# SERVICE BULLETIN

### BOTTOM FINISH ASSEMBLY

No. 221.1

#### THREAD LOCKING COMPOUND 1000, 1001, 1002, 1250

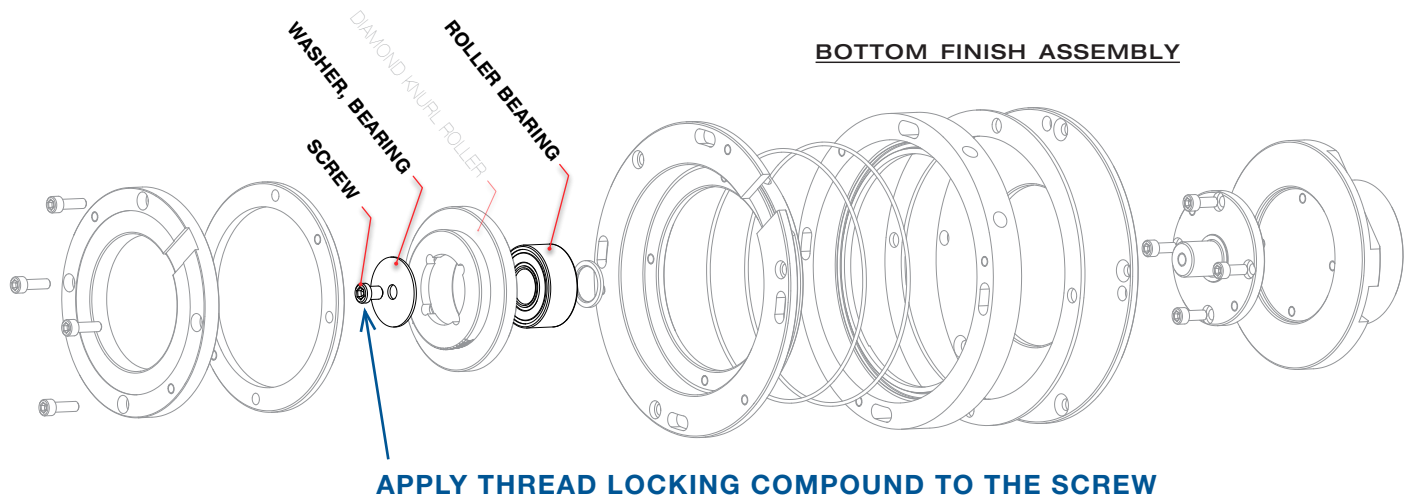
Field reports have indicated that the screw securing the washer to the roller shaft of the spac tooling is coming loose. This will damage the mandrel stems. We recommend that removable thread locking compound (blue #242) be applied to the screw to prevent it from coming loose.
